Service Bulletin

Subject: Bulletin No: 02-003/15

Last Issued: 12/17/2015

KNOCKING / SQUEAKING NOISE FROM FRONT SHOCK ABSORBER

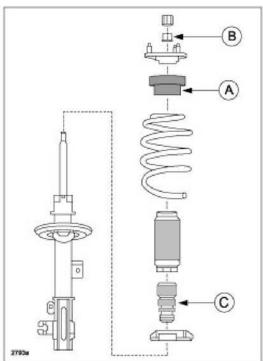
Some vehicles may exhibit a knocking / squeaking noise from the front shock absorber when driving on rough roads and/or when turning the steering wheel while the vehicle is stopped.

The noise may be due to:

- upper front strut bearing (A) damage. (CX-5 and Mazda6)
- stick/slip between the front strut bearing and coil spring.
- the bump stopper (C) may be contacting the strut bearing when the front shock absorber is compressed, causing a popping noise. (Mazda6 only)

To eliminate the noise, the following mass-production changes have been made:

- 1. The material and production method of the front strut bearing (A) has been changed. (CX-5 and Mazda6)
- 2. A protector has been installed onto the coil spring. (CX-5) and Mazda6)
- 3. The shape of the bump stopper (C) will be modified in the future. (Mazda6 only)
- 4. The shape of the coil spring has been changed. (CX-3 only)

NOTE: The piston rod nut (B) requires replacement. Customers having this concern should have their vehicle repaired using the following repair procedure.

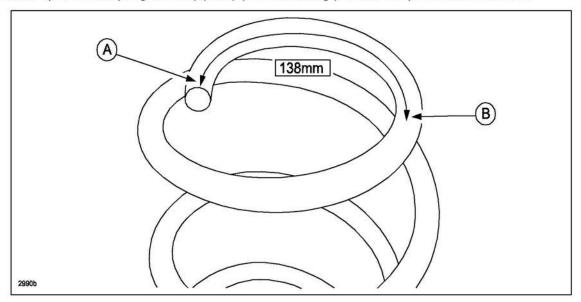
- 6. Starting from the top of the coil spring, degrease the spring 1.5 coils downward.
- 7. Cut a thin strip of paper to 138 mm in length (or use a cloth type measuring tape).

NOTE: For CX-3, use 130 mm in length.

- 8. Place the strip of paper (or cloth measuring tape) along the inner side of the coil spring starting at point (A).
- 9. Mark the spot on the spring where (B) is. (B) is the starting point for the protector installation.

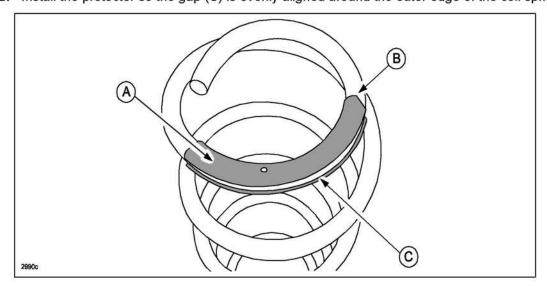
10. Install the protector (A) onto the coil spring aligning the end (slant cut side) with the marking at spot (B).

NOTE: Install the protector so the gap (C) is evenly aligned around the outer edge of the coil spring.
